SERVICE BULLETIN: JSB 040-2

Subject: Jabiru Mechanical Fuel Pump

Affected Models: All engines up to S/No. 22A3811 & 33A2768.

Figure 1 Mechanical Fuel Pump Brass Inlet Hose Tail location

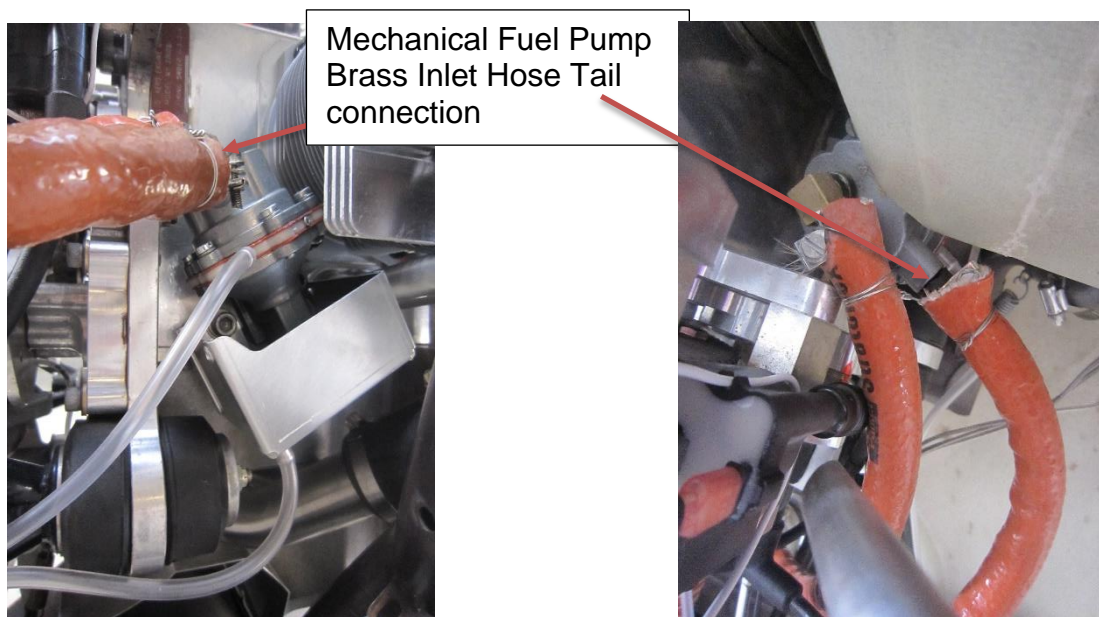
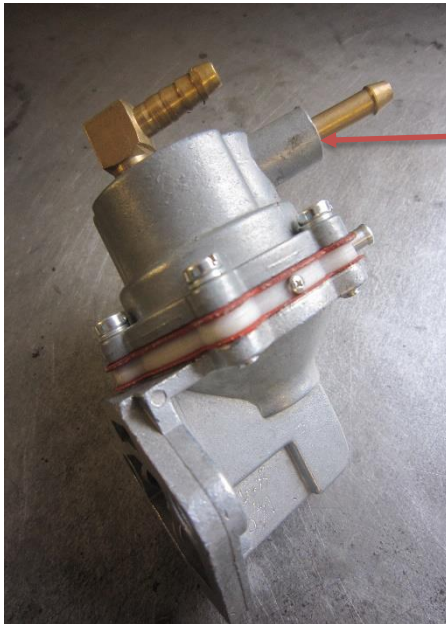
- 1) Remove the aircraft cowl.
- 2) Locate the mechanical fuel pump (the position on engine is shown in Figure 1).
- 3) Inspect the brass fuel inlet hose tail to fuel pump body connection for security of attachment.
